Re: Bishop Tube 2019 Remedial Investigation Report and Feasibility Study

Subject: Comments on the Bishop Tube 2019 Remedial Investigation Report and Feasibility Study Report

Figure 1 Comparison of sampling in MW-23 and MW-06

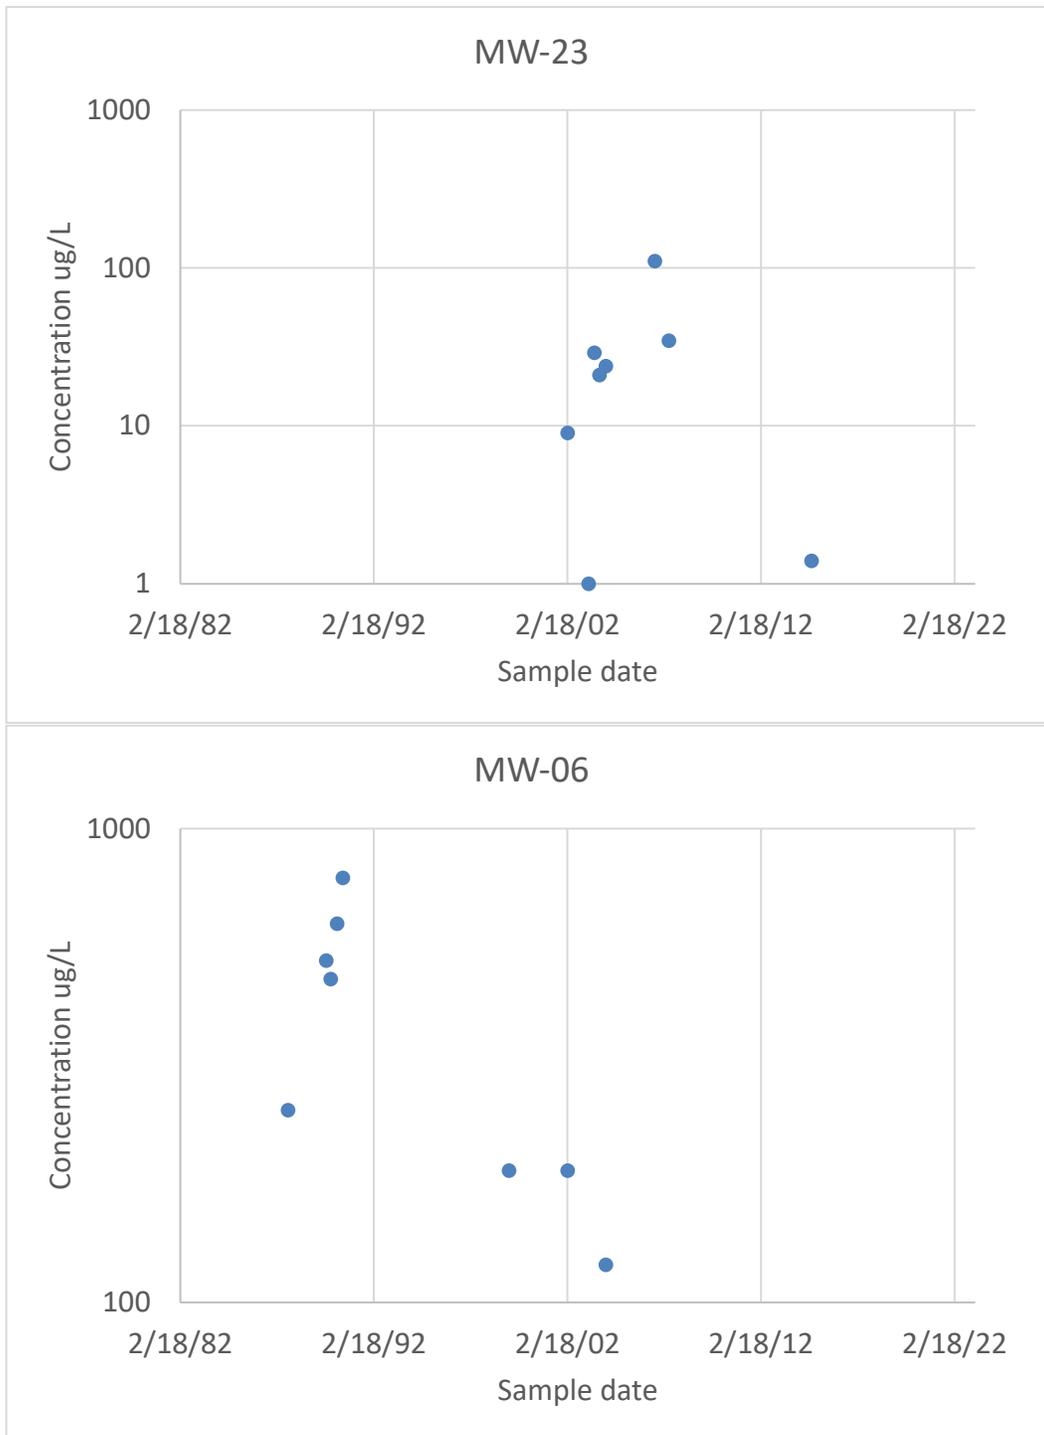
- c. It is difficult to conceive of any consistent specification that would include MW-23 but exclude MW-06, as is done in the RIR (see Figure 1).
- d. The methodology adopted in the RIR was to average the “half-lives” calculated by linear regression over all available measurements in Table B-1 for the wells in Table 2 of Appendix S. This methodology is incorrect, however, for at least two reasons. First, if such averaging over wells were appropriate, then the correct methodology requires averaging over all “decay rates” (both positive and negative), not averaging over “half-lives” (essentially the inverse of “decay rates”). Second, performing such averaging assumes that the average has some physical meaning — that the “decay rate” measurements in individual wells are all (imperfect) measures of the same quantity applicable to the whole site — but in this case, examination of the distribution of “decay rates” shows that the measurements are in fact not of the same quantity. Figure 2 shows a normal probability plot of the “decay rate” (λ) for all 51 monitoring wells satisfying the first criterion (≥ 4 points, ≥ 4 years). This distribution is indistinguishable from normal,³ and clearly the measurements are not all consistent with a single mean value. A formal likelihood ratio test confirms this — maximum likelihood estimates of mean and standard deviation of a normal distribution are 0.00029 per day and 0.00024 per day respectively, taking account of all the individual uncertainties, and the standard deviation estimate is non-zero ($p = 1e-97$).

Figure 2 Normal probability plot of “decay rates” in the 51 monitoring wells, with standard errors

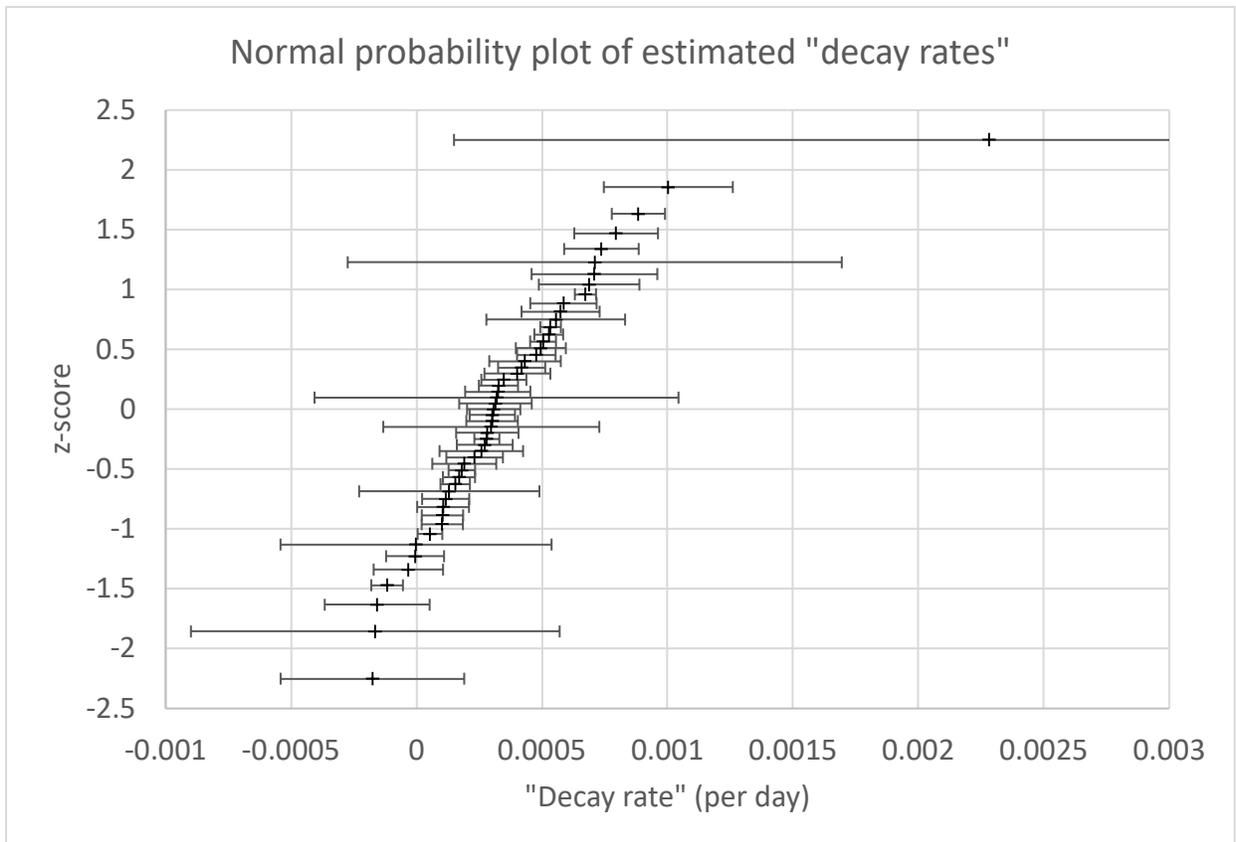
The implication of the non-zero standard deviation is that the “half-life” varies in different places on the site. This variation (if the methodology used to derive the value had any meaning; but see above and below) would need to be taken into account in any modeling. Indeed, approximately one third or more of the “half-life” measurements are consistent *with no “decay” at all* that those locations (see Figure 2). This conclusion is not surprising, given the results shown below, since the concentration at any particular well can be increasing, decreasing, or constant, dependent on multiple factors of which TCE degradation is only one. And in view of the microcosm tests (Baker, 2009, Appendix A; Roux, 2015a, Appendix B), such a finding for actual TCE degradation rates would also not be surprising; and such degradation rates remain to be measured, particularly any variation of half-life with depth and/or location.

Figure 3 Measured concentrations, the RIR “fit” to those concentrations, and a fit to those after 1995, and the modeled concentration in MW-15, with a line showing the assumed decay rate.

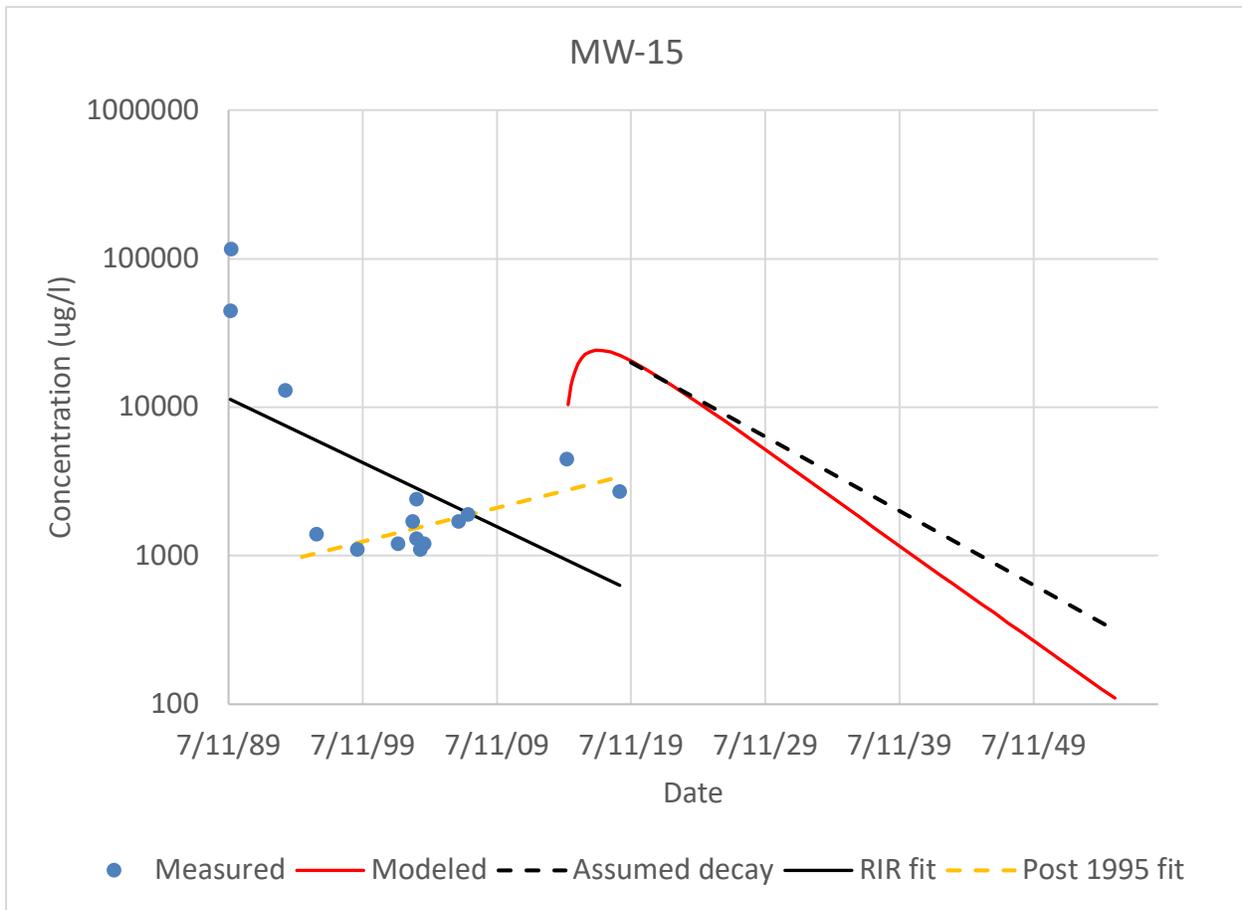
There are some wells in which variations in source strength are much more likely than decay to account for a major part of some concentration variations. Several wells have a very substantial decrease in concentration between measurements made prior to the mid 1990s and those made subsequent to that time. Particular examples in which decay as the only determinant of substantial reductions occurring between the 1980 to early 1990s and early 2000s seems unlikely are MW-15 (Figure 3) and MW-03 (Figure 4), with less obvious examples being MW-02 (Figure 5), MW-06 (Figure 6), and MW-08 (Figure 7), although such an effect cannot be ruled out in *any* well without adequate analysis that takes account of the propagation time and dispersion occurring between source and well. The example wells mentioned here are close to the putative source(s) of the TCE, so would reflect changes in source terms relatively soon after such source changes, and the changes would not be substantially extended in time by dispersion. The effect of source changes in wells further downgradient would occur later and be slower. Since the source term probably ceased sometime in the 1980s or as late as 1991, abrupt changes in nearby wells between the 1980s and late 1990s may quite plausibly be due to source changes.

Figure 3 (MW-15) also illustrates the disconnect between measured concentrations and the RIR modeling, for this well at least. The initial peak in the modeling is due to a higher concentration part of the plume passing by MW-15, and the faster drop-off in concentration at large times (compared with the decay rate, illustrated by the dashed black line) is due to the reducing concentration behind that higher concentration part of the plume (MW-15 is situated so that, in the modeling, a kink in the assumed 10,000 $\mu\text{g/L}$ contour will sweep across it as the whole plume migrates down-gradient; see Figure 46 of the RIR).

Figure 8 The absolute worst-case estimate of plume centerline concentration using the RIR model.

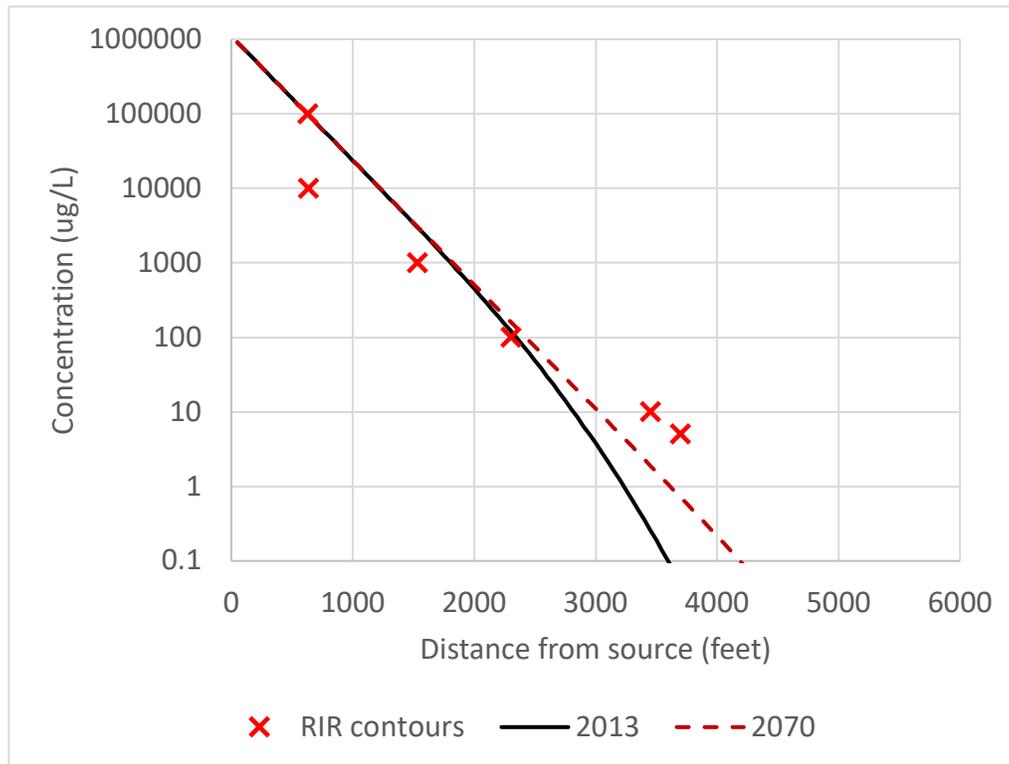
Clearly, with the parameter values used in the RIR, this worst-case plume would be in steady state out to 2,000 feet in 2013, and out to beyond 4,000 ft by 2070, and the 5 $\mu\text{g/L}$ contour would never extend beyond about 3,200 feet.

Figure 9 Showing that a constant source can match the RIR results with just a change in hydraulic conductivity.

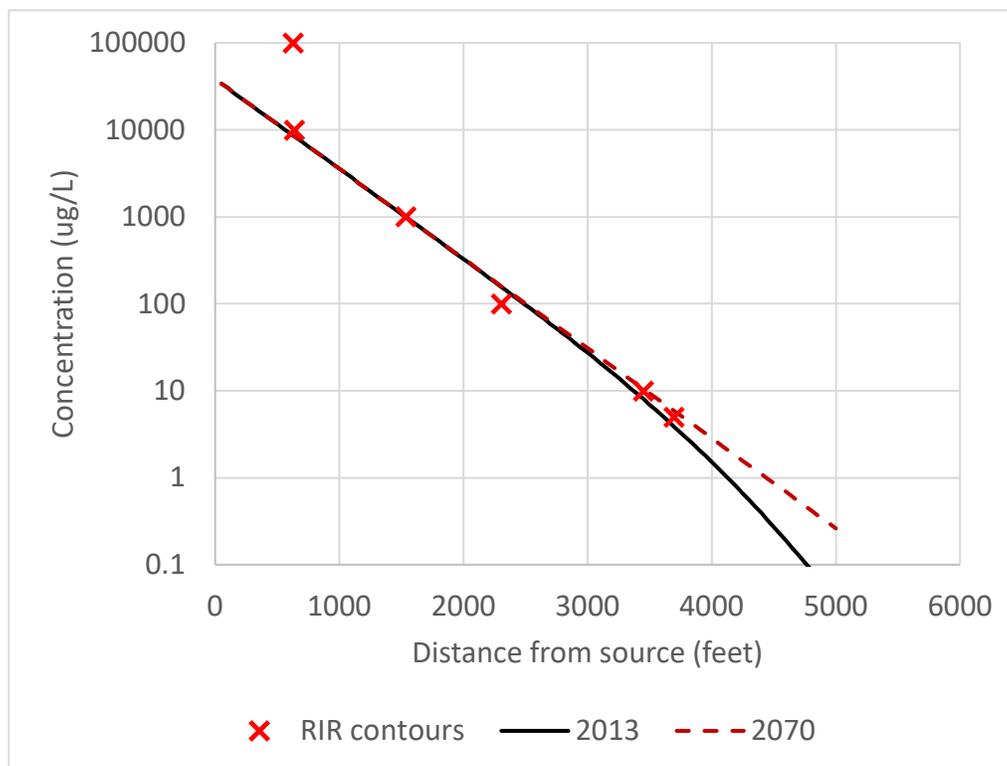
It is, however, not difficult to find parameter estimates within the range discussed in the RIR or in previous modeling (Baker, 2004), that allow matching the plume estimates of RIR Figure 46, at least beyond the 100,000 $\mu\text{g/L}$ contour. I consider that contour to simply reflect the anisotropy of the subsurface, with insufficient distance from the source(s) for the averaging effect of dispersion to have had sufficient effect for any smooth model to match it. For

example, simply increasing the estimated hydraulic conductivity to 2.129 ft/day and reducing the assumed (constant forever after 1951) source term gives Figure 9, which shows a plume in practical equilibrium to about 2,500 ft by 2013, and beyond 5,000 feet in 2070.

Figure 10 An example showing that the RIR might have substantially underestimated potential plume extent; and the effect of an immediate source term cleanup.

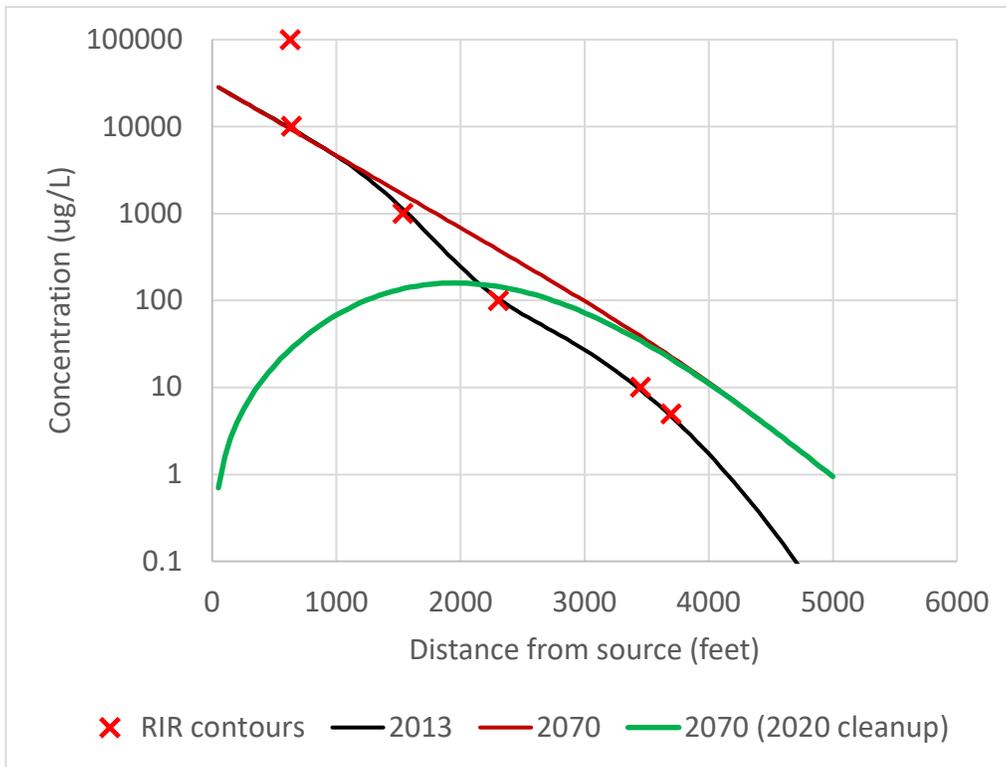
However, while it is possible to find combinations of parameters agreeing with the RIR conclusions, it is also possible to find combinations that disagree substantially. Thus Figure 10 shows an example with variable source term that matches the RIR estimated plume in 2013, but demonstrates that the plume might extend considerably further by 2070 (indeed, in this case, the 5 $\mu\text{g/L}$ contour would extend to approximately 4,500 ft by about 2100). This particular solution corresponds to a hydraulic conductivity of 1.776 ft/day and a degradation half-life of 3,506 days,⁷ which are fully as plausible as the values used in the RIR and are “calibrated” to the observed plume in 2013.⁸

Also shown on Figure 10 is the effect of stopping the entire source completely in 2020, to illustrate the importance of immediate action. The hypothetical source term was selected so that, in 1991, 70% of the source at that time was removed in an effort to illustrate the potential effect of stopping TCE releases at the site at that time. Any DNAPL TCE in the bedrock at that time would sink to deeper levels, with some presumably remaining trapped in blind pockets throughout the rock column. Gradual dissolution of both sources would probably provide a substantially reduced source strength compared with DNAPL TCE still flowing through the rock column. However, TCE present as DNAPL in or adsorbed to soil above the rock column would not be so affected by such a change — that would still be available for leaching into groundwater. Unfortunately, the RIR makes no attempt to evaluate the relative sizes of these sources, but merely assumes that both vanish entirely — the TCE in the rock column by implicit omission, and the TCE in the soil by simply assuming it away. Figure 10 arbitrarily assumes that the rock column is a negligible source after 1991, and that leaching from the soil could amount to 30% of the total at that time (and could continue forever). Removing the soil in 2020 would then correspond to the green curve, showing a substantial reduction in concentrations over the first 3,000 ft of plume by 2070.⁹

Figure 11 Concentration versus time at various distances for the example in Figure 10

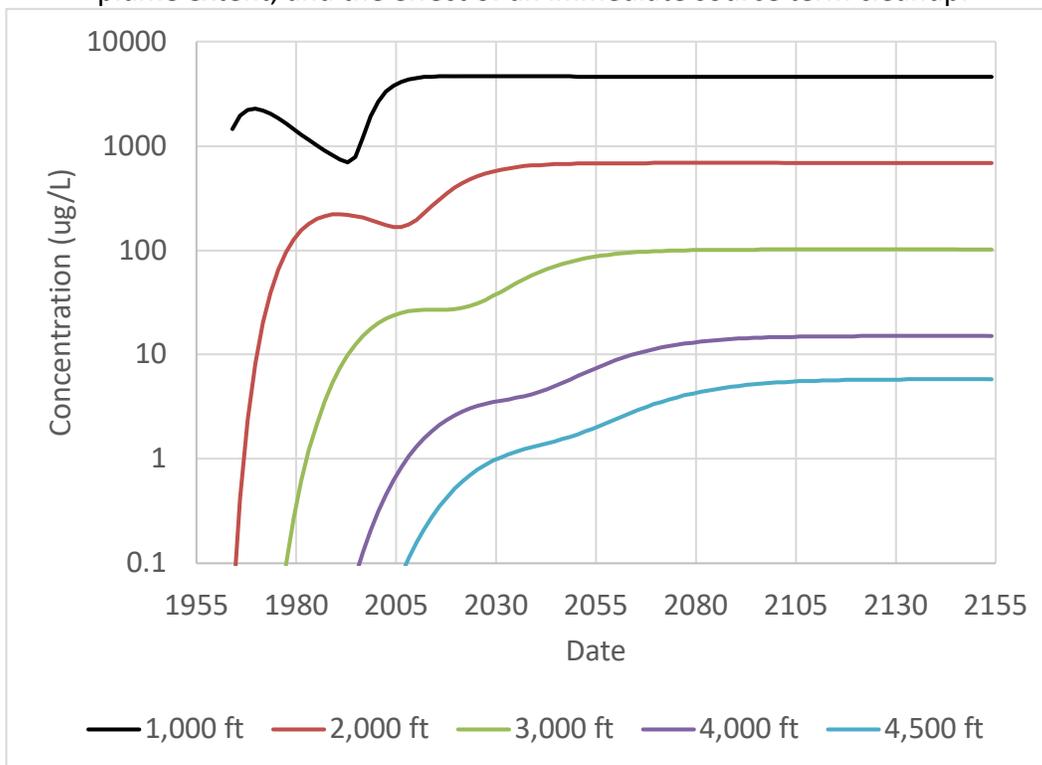
Concentration versus date curves at various down-gradient distances for the example shown in Figure 10 are shown in Figure 11. Noteworthy features include:

- Periods of decreasing concentration have nothing to do with TCE degradation. They are controlled by variations in source terms.
- The “decay rates” estimated from such periods would certainly vary by location, and probably by time frame.
- Ultimately, all concentrations tend to a constant value (this occurs because of the assumption of a continuing source).
- The time to reach the ultimate value can extend well beyond the modeling time-frame of the RIR (which was limited to 2055).

Figure 12 Concentration versus date curves at various distances for the clean-up scenario in Figure 10

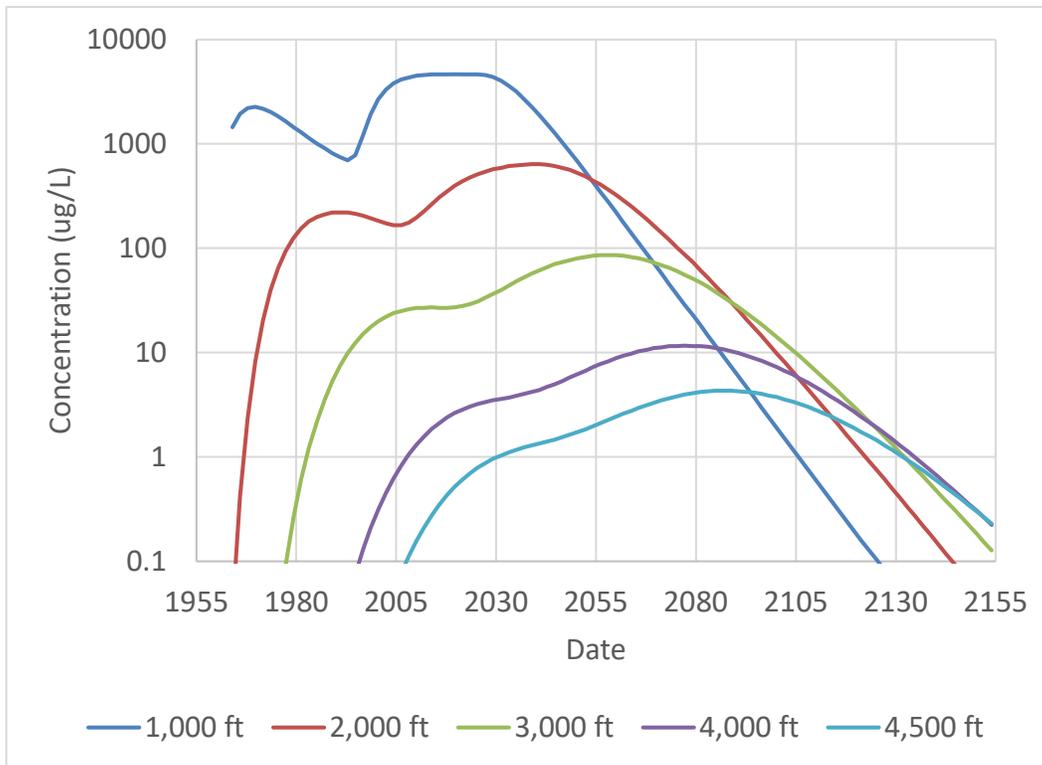
The concentration versus date curves corresponding to the cleanup scenario of Figure 10 are shown in Figure 12. Further noteworthy (and generic) features (compared with Figure 11) are:

- After a time delay corresponding to the propagation time from the source, the concentrations start to decline almost exponentially with time.
- Despite the appearance on Figure 12 that the declining curves could be parallel and straight, the exponential declines are different at different times and distances, and none of them correspond to the TCE degradation half-life (they are more rapid).
